PLANNING, ZONING, & BUILDING DEPARTMENT
PZ&B Staff Combination Memorandum: Town Council and Architectural Commission

SUBJECT: ZON-23-072 (ARC-23-094) 241 WORTH AVE (COMBO)

MEETING: JANUARY 24, 2024 ARCOM
FEBRUARY 14, 2024 TOWN COUNCIL

Current Proposal

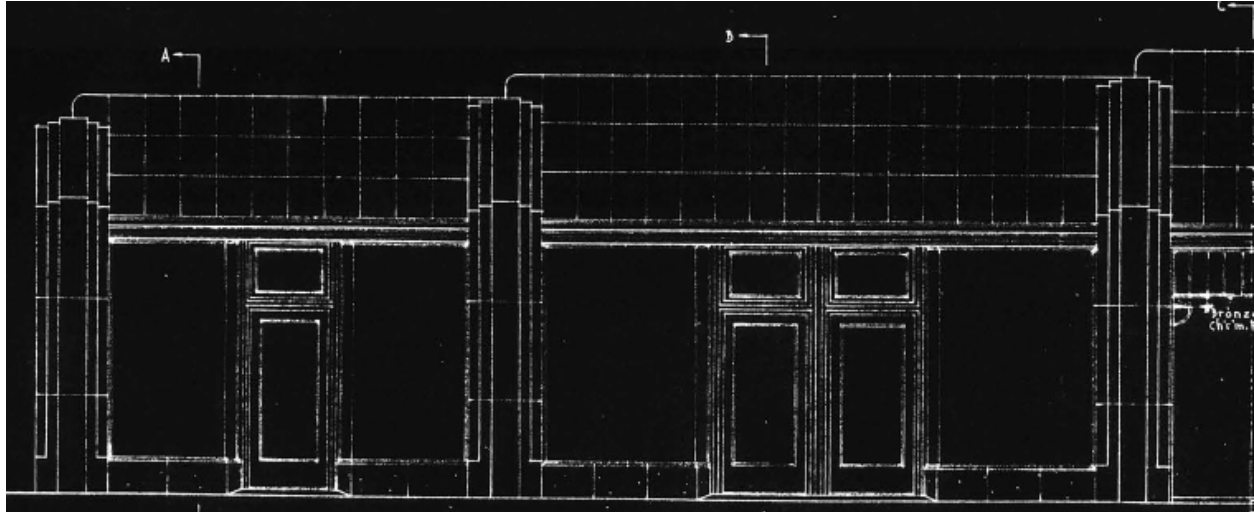
The applicant is now proposing a more substantial restoration of the front façade of the existing building within all bays, the applicant does intend on initially modifying the westernmost bay (Brioni) to recall aspects of the original design in the re-introduction of the fluted art deco pilasters.

wo-story addition takes many of the design cues from the original Art Deco design, most notably in the rhythm and the breakdown of the bays. The rear of the new construction consists open two upper levels of open-air walkways and catwalks as well as two new egress stairs with a vertical metal picket style railings. This rear façade shall not be visible from the right-of-way of across from the Peruvian Ave parking lot. However, while not a primary or secondary façade, the applicant has made considerable efforts to refine and improve this “rear facede”. There are two existing curvilinear stairs (that do not meet today’s code requirements for life safety) within the courtyard that provide access to the second floor of Le Bilboquet. These features are proposed to be demolished in order to address code compliant life safety and egress requirements as determined by the Fire Marshal. It must be
